## Critical Review of NLR Reports CR 93080 C and CR 94238 C, both on the Analysis of the DC-10 crash at Faro Airport, 21 Dec. 1992

1. Introduction. The two NLR reports CR 93080 C and CR 94238 C were reviewed at the request of lawyers who subpoenaed both the State and Martinair for not telling the truth about the accident to victims and their next of kin, and for pilot errors respectively. The first NLR report CR 93080 C was already issued on 19 Feb. 1993, one week after the NTSB mailed the DFDR Factual Report (DCA-93-RA-011 dated 12 Feb 1993) from Washington, D.C. to the Portuguese Commission. Comments and remarks are included in text boxes in both attached NLR reports. Below, a summary and conclusions are presented. First, a brief summary is presented of airplane systems and a VOR/DME approach that was the only option to approach Faro airport.

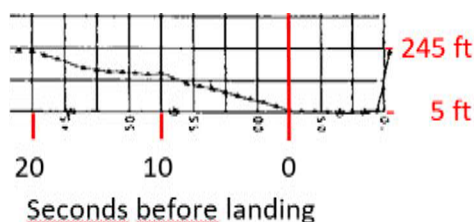
13. The word 'estimate' is used way too many times for a scientific report. Accelerations and calculated winds were used to determine the flight path, but this 'estimated' path does not agree with the analysis of both heading and airspeed using objectively measured DFDR data. What NLR calls windshear, microburst, updraft or downdraft are in fact the motions that were either common during a non-precision approach in

turbulence or induced by the inappropriate, near continuous control force inputs by the copilot while the vertical speed command or the CWS modes of the autopilot engaged (AIDS data). These force control input data might not timely have been made available by DTSB but still, NLR continued the analysis, obviously assuming an ideal continuously descending flight path, a perfect pilot, and flawless computer models. None of these happened. Blind faith in numbers and equations, that were obviously never verified with data of an airplane that really encountered a windshear, led to a report that is definitely incorrect and cannot be used to prove the occurrence of windshear during the approach to Faro, as its title suggests.
